ADDENDUM #2

To: Known Qualified Firms
From: Porter Co. Dept. of Development & Storm Water Management
Date: March 9, 2021
Subject: Ludington Ditch, Arm 19 – Ditch Reconstruction
Construction Services

PROJECT:	LUDINGTON DITCH, ARM 19 - DITCH RECONSTRUCTION
LOCATION:	CR 450 S TO CONFLUENCE W/ LUDINGTON DITCH
SHEET TITLE:	SHEET 1 - COVER

PROJECT: LUDINGTON DITCH, ARM 19 - DITCH RECONSTRUCTION
 LOCATION: CR 450 S TO CONFLUENCE W/ LUDINGTON DITCH
 SHEET TITLE: SHEET 2 - PLAN

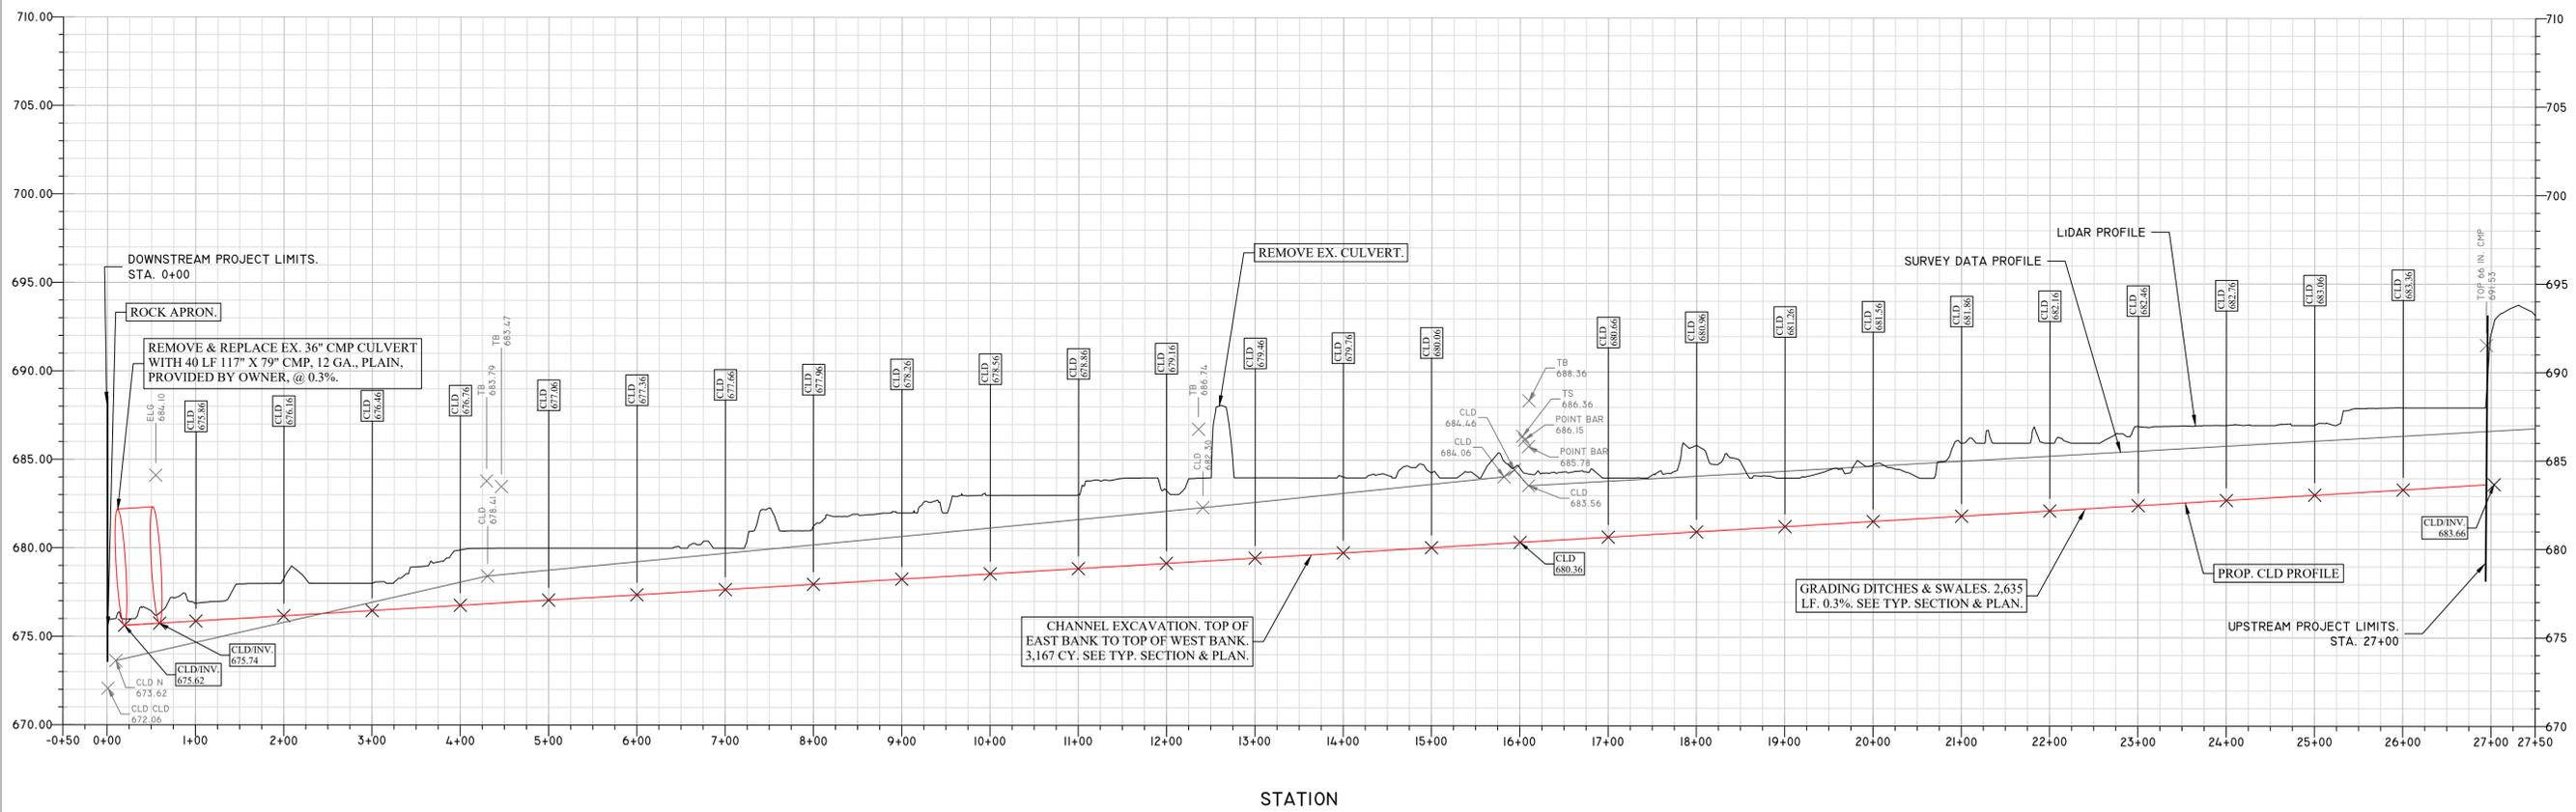
The construction plans have been revised to include a second temporary construction entrance off of CR 100 W to allow for the existing farm lane to be used as a construction access route. The farm lane shall be restored to as near a condition as possible that existing prior to the start of work.

UNIFORM TOE OF SLOPE

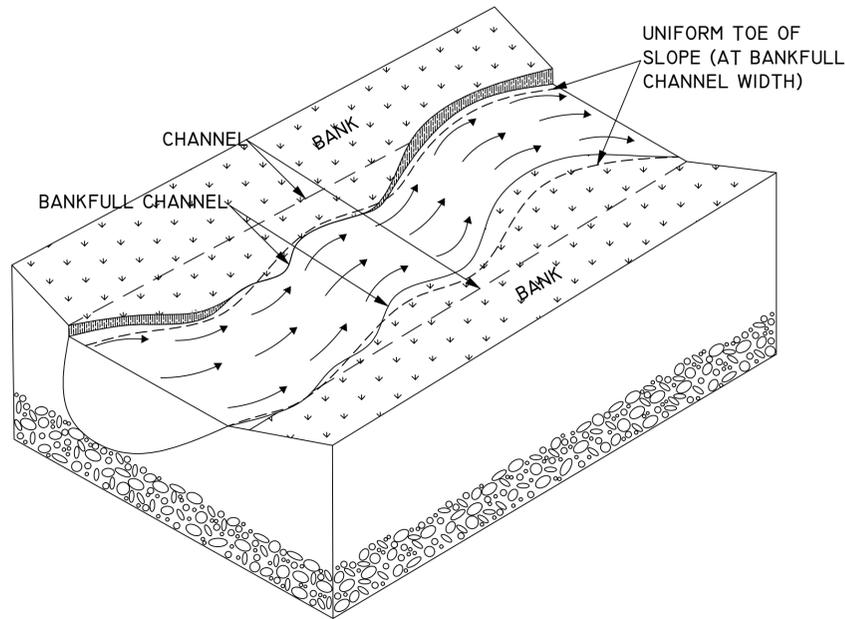
Q6: In some areas, the existing bottom width of the ditch is approximately 10 feet. Should the proposed bottom width match the existing, or should it be filled in to the proposed 5 foot bottom width?

A6: The project requires the excavation of approximately 2-3 feet of material. The channel should be excavated to 5 feet wide, per the contract documents. The new channel should be blended with the existing ditch banks to create a uniform toe of slope which may require filling in the stream banks in some areas.

ROCK APRON

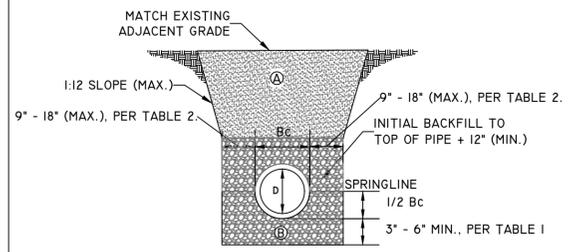
Q8: Can INDOT No. 2 be used instead of INDOT No. 5 for the rock apron?

A8: Yes.

DITCH TYP. SECTION

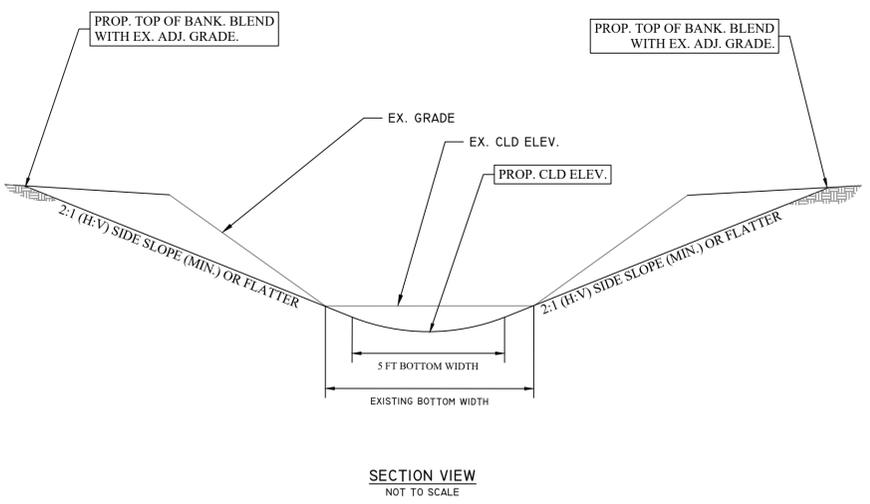
To clarify, erosion control blanket will be placed in the ditch bottom (i.e. toe of slope to toe of slope) during the performance of the work only if it is dry during the performance of the work. Please provide a price for Item No. 8B – Erosion Control Blanket, NAG C125BN on the attached revised Basis of Quote Form. It may be determined during the performance of the work that the installation of erosion control blanket on the ditch bottom is not necessary due to site conditions.

Q3: Does erosion control blanket need to be installed in the bottom of ditch if there is continuous flow through the ditch?

A3: No, if the ditch has constant water in the bottom of ditch, erosion control blanket will not be installed in the ditch bottom. If the ditch has a dry bottom, then erosion control blanket will be installed. Addendum #2 provides separate pay items for the erosion control blanket to account for this.

- TOE OF SLOPE TO TOE SLOPE: RESTORE W/ TOPSOIL, FERTILIZER, DITCH SEED, AND EROSION CONTROL BLANKET (C125BN), PER TECHNICAL SPECIFICATIONS.
- TOP OF BANK TO TOE OF SLOPE: RESTORE W/ TOPSOIL, FERTILIZER, DITCH SEED, AND EROSION CONTROL BLANKET (NAG S75BN) AND/OR STRAW MULCH (FLAT AREAS), PER TECHNICAL SPECIFICATIONS.
- OTHER AREAS: RESTORE W/ TOPSOIL, FERTILIZER, COVER CROP SEED OR DITCH SEED & STRAW MULCH.
